## **C147 KOROROIT PRECINCT STRUCTURE PLAN**

Exhibition Submission by Melton City Council, 22 August 2016

Item 12.11	Amendment C147 to the Melton Planning Scheme - Kororoit Precinct Structure Plan Council Submission
Appendix 3	Melton City Council Submission to C147 Kororoit Precinct Structure Plan

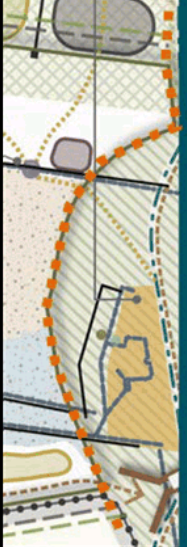
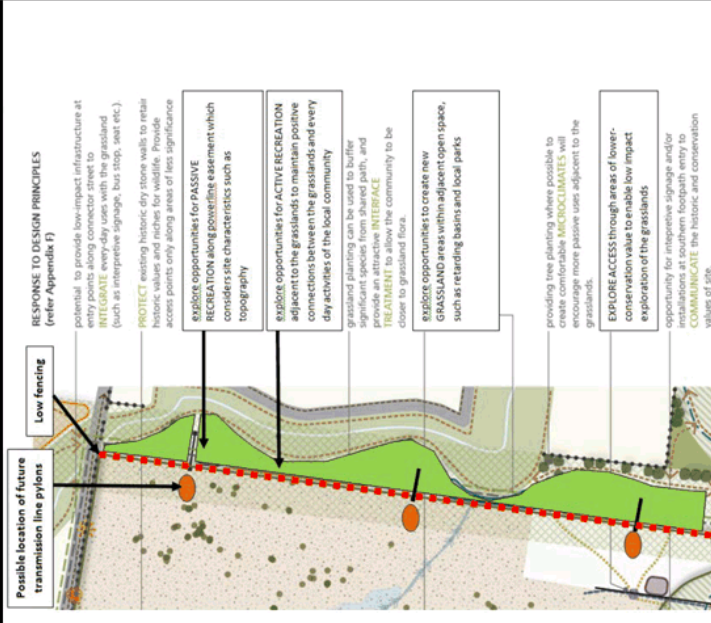
Item No.	Section, Page no.	Comment	Recommended Change
144	Figure 9, p.100	<p>Agreements. The location of paths / tracks through the conservation reserve should be left to the future public land manager to determine their location and construction. Remove proposed paths and entry points from the plan.</p> <p>A local access street should be located between the conservation reserve and the local park as this will create a more legible road network, and will assist in the maintenance of the grassland.</p> <p>The text '<i>Proposals are subject to future funding and detail design by land</i>' is confusing. This should be changed to reference '<i>the future land manager</i>'.</p> <p>Response to Design Principles</p> <p>Under the design principles change some of the statements to better manage community expectations, as some of the infrastructure shown or recreation opportunities may not be able to be provided:</p> <ul style="list-style-type: none"> <li>The second statement change '<i>locate recreational opportunities...</i>' to '<i>encourage the location of recreational opportunities...</i>'</li> <li>The last statement change '<i>provide opportunities for passive recreation...</i>' to '<i>explore opportunities for passive recreation...</i>'</li> </ul> <p>Notes section</p> <ul style="list-style-type: none"> <li>There is an error in the numbering – combine notes 1. a. and b., and 1. c. and d.</li> <li>There is an error in the numbering. There are two x 2. The second 2. Should be combined with 3.</li> </ul>	<p>and <i>detail design by land</i>'. This should read '<i>Proposals are subject to future funding and detailed design by the future land manager</i>'.</p> <ul style="list-style-type: none"> <li>Remove reference to '<i>existing footpath</i>'.</li> <li>Show a local access street between Conservation Area 1 and the local park to the north of it.</li> </ul> <p>Change the text in the following design principle responses:</p> <ul style="list-style-type: none"> <li>The second statement change '<i>locate recreational opportunities...</i>' to '<i>encourage the location of recreational opportunities...</i>'</li> <li>The last statement change '<i>provide opportunities for passive recreation...</i>' to '<i>explore opportunities for passive recreation...</i>'</li> </ul> <p>In the notes section resolve the following numbering errors:</p> <ul style="list-style-type: none"> <li>Combine notes 1. a. and b., and 1. c. and d.</li> <li>There are two x 2. The second 2. Should be combined with 3.</li> </ul>

<p>Do DELWP and the Federal Government support this plan? In particular do they support the paths and embellishments shown within the conservation area?</p>	<p>Council seeks clarification that DELWP and the Federal Government support the paths and embellishments shown within this conservation area.</p>
		<p>Council is concerned with the depiction of paths through this</p>	<p>Council has concerns with the detail shown in this plan.</p>

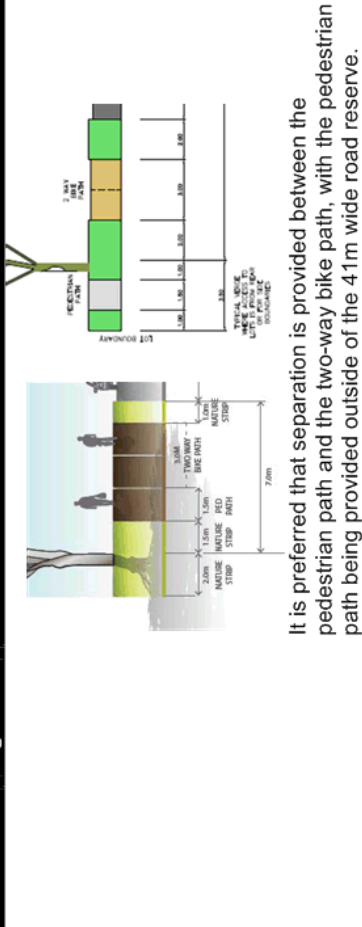
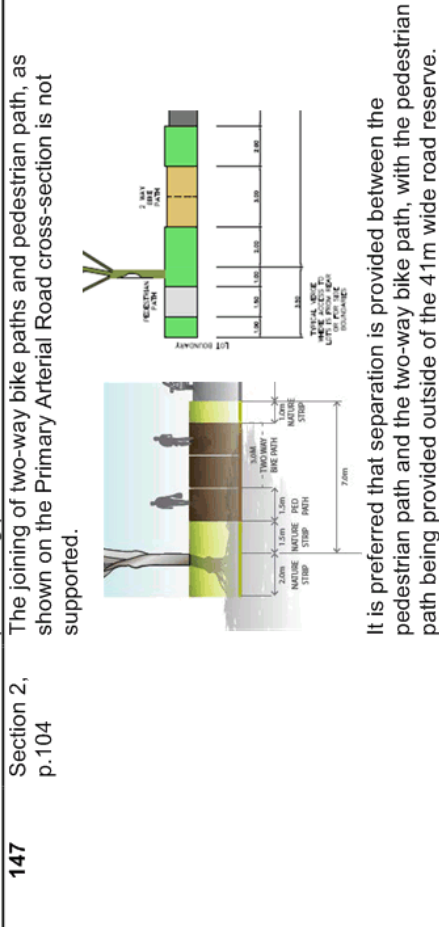
Item No.	Section, Page no.	Comment	Recommended Change
		<p>conservation area as there is no certainty that they can be delivered, and may conflict with State and Federal Agreements. The location of paths / tracks through the conservation reserve should be left to the future public land manager to determine their location and construction. Remove proposed paths and entry points from the plan</p> <p>The text '<i>Proposals are subject to future funding and detail design by land</i>' is confusing. This should be changed to reference '<i>the future land manager</i>'.</p> <p>The figure should show the indicative sites for future high voltage transmission pylons as this is infrastructure that has been identified as being potentially required within the conservation area.</p> <p>There are significant gaps in the low fencing around the grassland reserve. The low fencing should be pulled back to the boundaries of the nature conservation reserve to serve as a clear boundary of the conservation reserve and serve as a maintenance boundary for the different areas of open space.</p> <p>A section of the shared path is shown dipping south below the <i>Kororoit Creek Hut Foundations and Dry Stone Wall</i> complex (H7822-2321). This shared path should be moved north to follow the boundary of the Growing Grass Frog habitat border with Conservation Area 2, to take advantage of the flat topography and remove the path from being flooded. Council has no objection to sections of dry stone wall being removed to facilitate this outcome. Likewise the sewer infrastructure should be shifted to follow this alignment too (the path and sewer realignment are shown in orange dots below).</p>	<p>The plan should be more conceptual and focus on the interface areas and significant intrusions only. Simplify Figure 9 in the following manner:</p> <ul style="list-style-type: none"> <li>Remove paths and tracks through the conservation reserve, and corresponding entry points.</li> <li>Change text '<i>Proposals are subject to future funding and detail design by land</i>'. This should read '<i>Proposals are subject to future funding and detailed design by the future land manager</i>'.</li> <li>Show indicative location for future pylons.</li> <li>Show low fencing around the western, northern and eastern edges of Conservation Area 2.</li> <li>The shared path should follow the Growing Grass Frog habitat boundary for its full length and be north of the <i>Kororoit Creek Hut Foundations and Dry Stone Wall</i> complex (H7822-2321). The sewer infrastructure should also follow this alignment</li> </ul> <p>Simplify Figure 9 and the design principles as shown in the diagram below:</p>

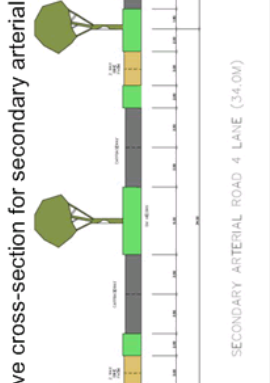
Item No.	Section, Page no.	Comment
Recommended Change		<p><b>High Voltage Transmission Easement</b></p> <p>The embellishment of the high voltage transmission (HVT) line easement goes into too much detail. Table 6 and Figure 4 in the PSP have been prepared to provide information on how the land in the HVT easement should be developed. The detail in Figure 9 should be more conceptual and reflect the information in Table 6 and Figure 4.</p> <p>Council is concerned that:</p> <ul style="list-style-type: none"> <li>• There is no certainty that the easement authority will allow the level of embellishment proposed.</li> <li>• The embellishment of the HVT to the level proposed would be expensive and may impact on the embellishment of other local parks in the area.</li> <li>• The embellishment shown on the plans can set up an unrealistic expectation of the future local community on what will be provided.</li> </ul> <p>The embellishment of the HVT easement should be left for the developer and Council to liaise with the easement operator. Table 6 will provide enough direction for the use of the easement.</p> <p><b>Response to Design Principles</b></p> <p>Under the design principles change some of the statements to better manage community expectations, as some of the infrastructure shown or recreation opportunities may not be able to be provided.</p>
